Model: Model G-P1	Date: 24-Feb-05	No.: RG104001a
-------------------	-----------------	----------------

Subject: Engine firmware release note for G-P1		Prepared by: K. Moriizumi	
From: 1st Tech. Support Sec. Service Support Dept.			
Classification:	<input type="checkbox"/> Troubleshooting <input type="checkbox"/> Mechanical <input type="checkbox"/> Paper path <input checked="" type="checkbox"/> Other ()	<input type="checkbox"/> Part information <input type="checkbox"/> Electrical <input type="checkbox"/> Transmit/receive	<input type="checkbox"/> Action required <input type="checkbox"/> Service manual revision <input type="checkbox"/> Retrofit information

This RTB has been issued to announce the firmware release information for the Model G-P1 engine board.

2-1. Fusing pressure adjustment procedure

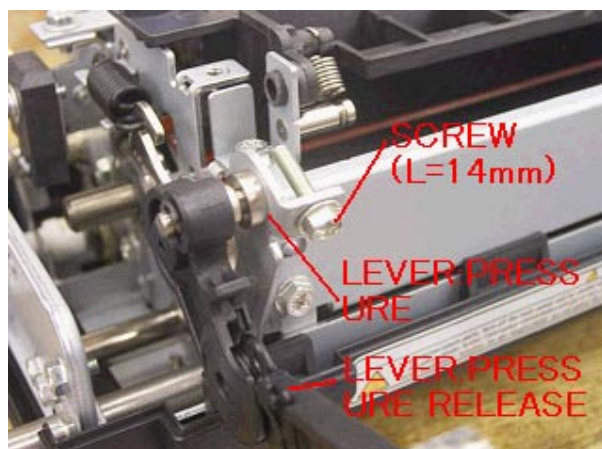
- 1) Remove the upper cover of the fusing unit. (4 screws)
- 2) Install the screws in the screw holes of the fusing pressure lever in both sides of the fusing unit as shown in Fig.1. (M3 x 14mm screws are best for this adjustment.)
- 3) Please confirm that the pressure release levers move smoothly and the edge of the screw touches the frame when fusing pressure is applied as shown in Fig.2.
- 4). Reinstall the upper cover.

To correct the fusing ability after reducing the fusing pressure, the following SP setting changes are required.

The following screws are suitable for this adjustment.

03530140N: SCREW:M3X14

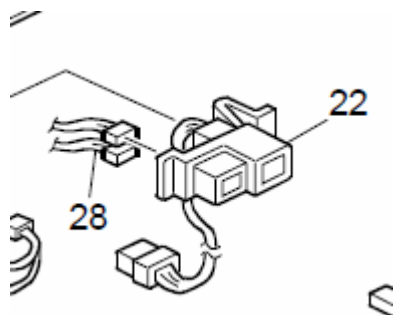
Change/Reason:

- 1) The P/N of the fusing drawer harness was changed (parts standardization).
- 2) Index numbers #22 and #28 in the parts list were reversed.

Old part number	New part number	Description	Q'ty	Int	Page	Index	Note
G1025455	G1905499	Harness – Fusing: Drawer	1		9	22→28	
G1025413	---	Harness – Power Supply Unit: (NA)	1		9	28→22	
G1025412	---	Harness – Power Supply Unit: (EU)	1		9	28→22

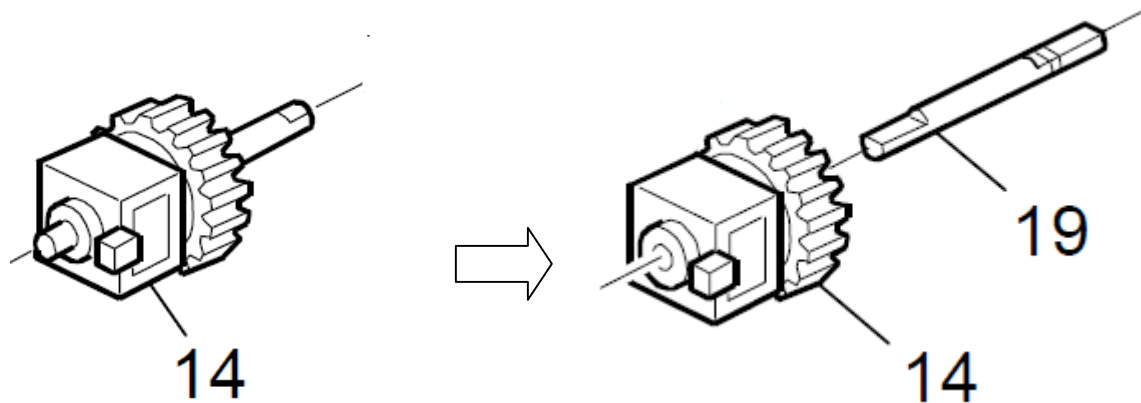
Change/Reason: This part was missing from the Parts Catalog.

Old part number	New part number	Description	Q'ty	Int	Page	Index	Note
-	GA145008	Shaft: Development	1		33	19
